Re: Mister Car Wash
2161 Gibson Blvd. SE
Traffic Circulation Layout
Engineer's Stamp 07-25-22 (M15-D021B)

Based upon the information provided in your submittal received 10-18-22, the above referenced plan cannot be approved for Building Permit until the following comments are addressed:

<p>MCW - ALBUQUERQUE NEW MEXICO</p> <p>PREPARED FOR MISTER CAR WASH</p> <p>ALBUQUERQUE NEW MEXICO</p>	<p>SHEET NUMBER C400</p>	<p>SITE, DIMENSION CONTROL AND PAVING PLAN</p>	<p>KHA PROJECT 068918301</p> <p>DATE JULY 2022</p> <p>SCALE AS SHOWN</p> <p>DESIGNED BY JCG</p> <p>DRAWN BY JCG</p> <p>CHECKED BY LAN</p>		<p>Kimley»»Horn</p> <p>13465 NOEL ROAD, SUITE 700, DALLAS, TX 75240 PHONE: 972-770-1300 FAX: 972-289-3820 WWW.KIMLEY-HORN.COM</p> <p>© 2022 KIMLEY-HORN AND ASSOCIATES, INC.</p>	No.	REVISIONS	DATE	BY

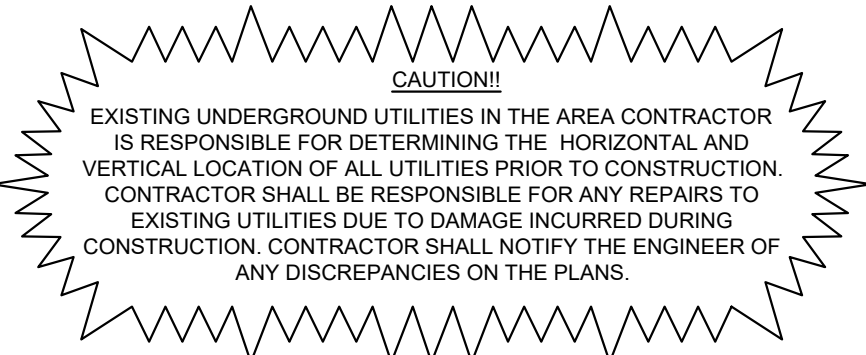
1. List the number of Bicycle parking spaces required by the IDO.
2. According to NM Accessible parking spaces requirement, 2 ADA parking spaces need to be provided, if there are more than 25 parking space. See attached.

3. Please provide design details (width, radii, reference COA std dwg, and ect...)for both accesses off Gibson Blvd. and Miles Rd.
4. Shared access agreement needs to be provided between Lot A and Lot B.

5. Sidewalk need to be built from property line to property line off Miles Rd.
6. Please clarify if there is an existing sidewalk off Gibson Blvd. or, are going to build one? Provide the existing sidewalk width.

7. The ADA accessible parking sign must have the required language per 66-7-352.4C NMSA 1978 **"Violators Are Subject to a Fine and/or Towing."** Please call out detail and location of signs.

8. The ADA access aisles shall have the words **"NO PARKING"** in capital letters, each of which shall be at least one foot high and at least two inches wide, placed at the rear of the parking space so as to be close to where an adjacent vehicle's rear tire would be placed. (66-1-4.1.B NMSA 1978)

9. ADA curb ramps must be updated to current standards and have truncated domes installed.
10. Motorcycle parking spaces shall be designated by its own conspicuously posted upright sign, either free-standing or wall mounted per the zoning code.

11. The pavement marking "MC" should be shown in the opposite direction for Motorcycles entering the parking space.
12. All bicycle racks shall be designed according to the following guidelines:

13. Bicycle racks shall be sturdy and anchored to a concrete pad.
14. A 1-foot clear zone around the bicycle parking stall shall be provided.
15. Bicycle parking spaces shall be at least 6 feet long and 2 feet wide.

16. List radii for all curves shown; for passenger vehicles. Radius for delivery trucks, fire trucks, etc. is 25 ft. or larger.
17. Per the IDO, a 6 ft. wide ADA accessible pedestrian pathway is required from the public sidewalk to the building entrances. Please clearly show this pathway and provide details.

18. Refuse vehicle maneuvering shall be contained on-site. The refuse vehicle shall not back into the public right of way.; provide a copy of refuse approval.

19. Provide a copy of Fire Marshall approval.
20. All one-way drives shall have "One Way" and "Do Not Enter" signage and pavement markings. Please show detail and location of posted signs and striping.

21. Show the clear sight triangle and add the following note to the plan: "Landscaping and signage will not interfere with clear sight requirements. Therefore, signs, walls, trees, and shrubbery between 3 and 8 feet tall (as measured from the gutter pan) will not be acceptable in the clear sight triangle.

22. Please specify the City Standard Drawing Number when applicable.
23. Provide notes showing what work is included and on the work order and the private work on site.

24. Work within the public right of way requires a work order with DRC approved plans.
25. Please add a note on the plan stating "All improvements located in the Right of Way must be included on the work order."

26. Add a note stating "All broken or cracked sidewalk must be replaced with sidewalk and curb & gutter." A build note must be provided referring to the appropriate City Standard drawing.
